Subject: Arkansas Nuclear One - Units 1 and 2
Docket Nos. 50-313 and 50-368
License Nos. DPR-51 and NPF-6
IPEEE Supplemental RAI Response (TAC Nos. M83588 and M83589)

**Supplemental RAI Responses Regarding IPEEE
Dated February 7, 2000 (0CNA020004)**

DRAWING NO E-2751
SHEET 22
REVISION 4
APPROVED REVISION
SEE APERTURE CARD
REDRAWN AS BUILT: DRW 95-82492
REDRAWN AS BUILT: DRW 97-84336
REVISION DESCRIPTION
DATE
REV

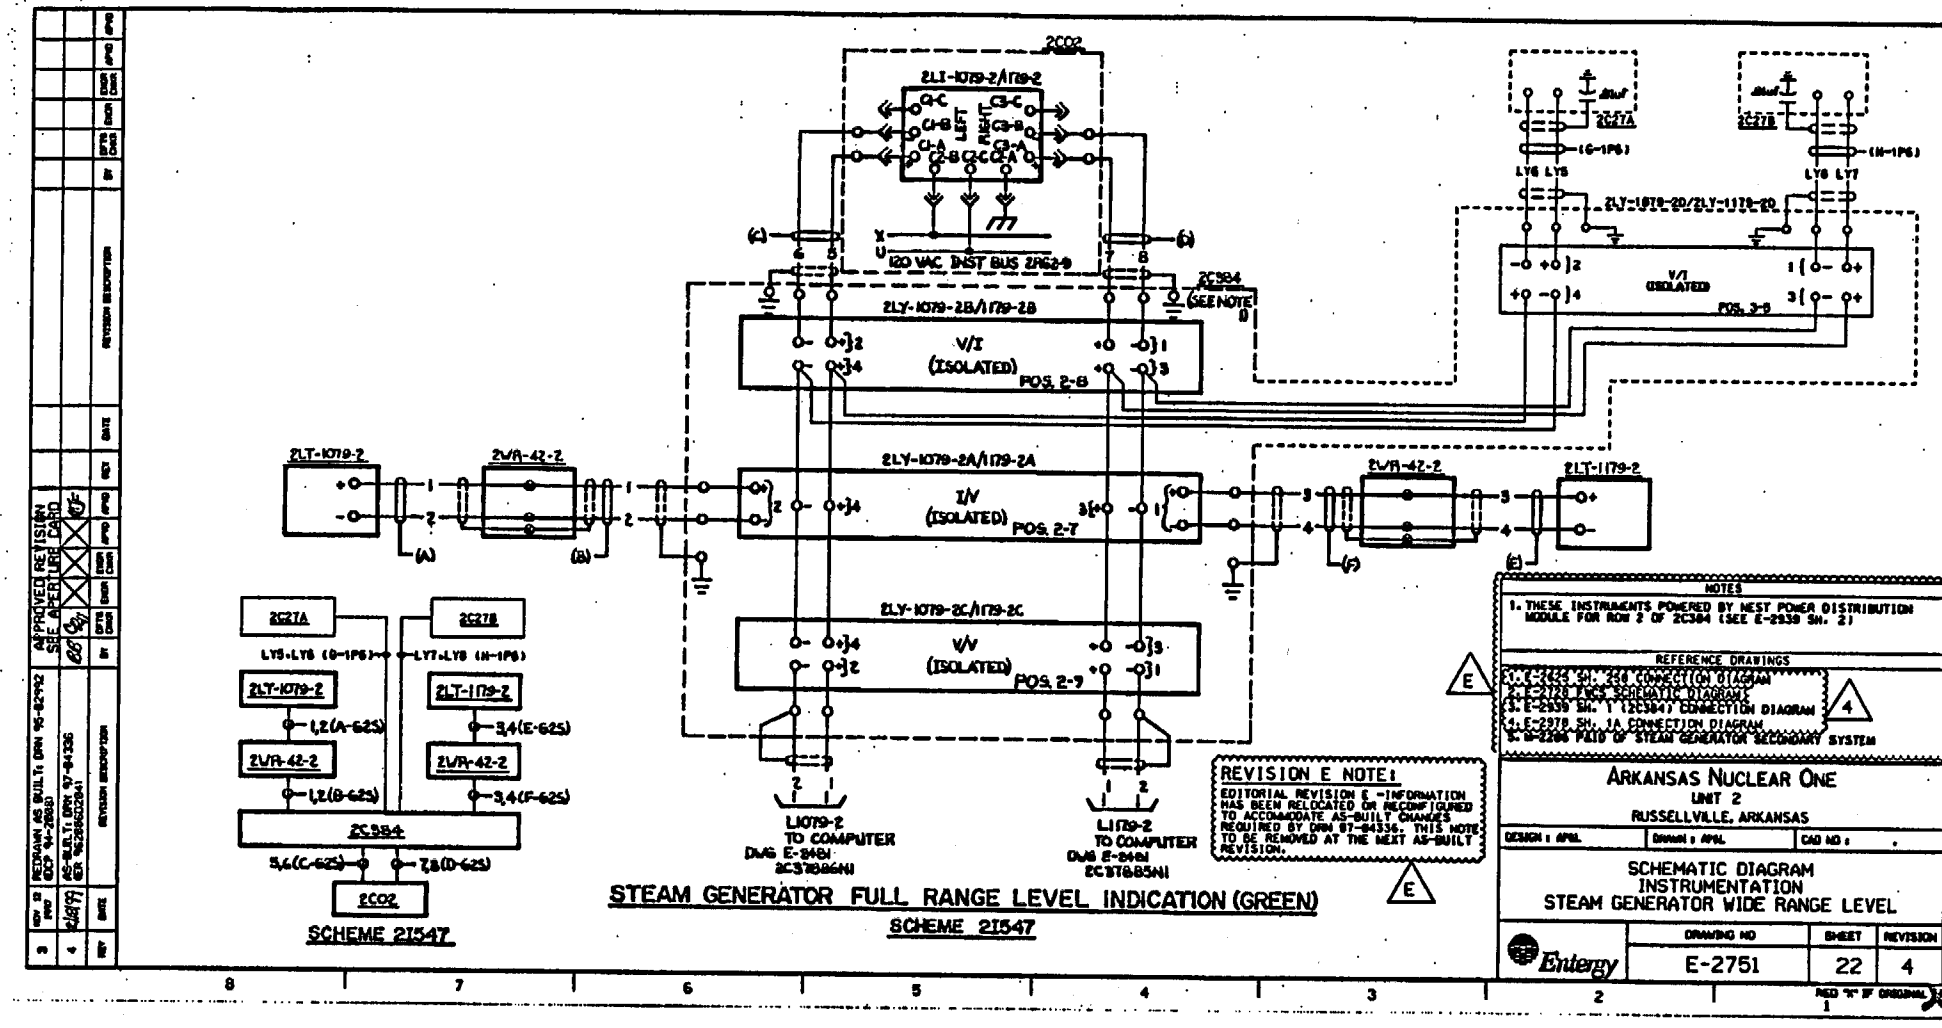
a) Please provide a description and location of the signal conditioning circuitry that would be used to isolate control room circuits in the event of a fire-induced control room abandonment.

Electrical isolation is achieved by removing control power (i.e., opening the associated breakers) to the required safe shutdown components. Required instrumentation is monitored via the safety parameters display system (SPDS). Inputs to SPDS are isolated from the control room via appropriate signal conditioning devices. A description of the SPDS and the associated isolation devices was previously submitted on July 1, 1982 (refer to Appendix A of the submittal), and subsequently approved by an SER dated May 13, 1983. A typical example of the instrumentation schematic is attached.
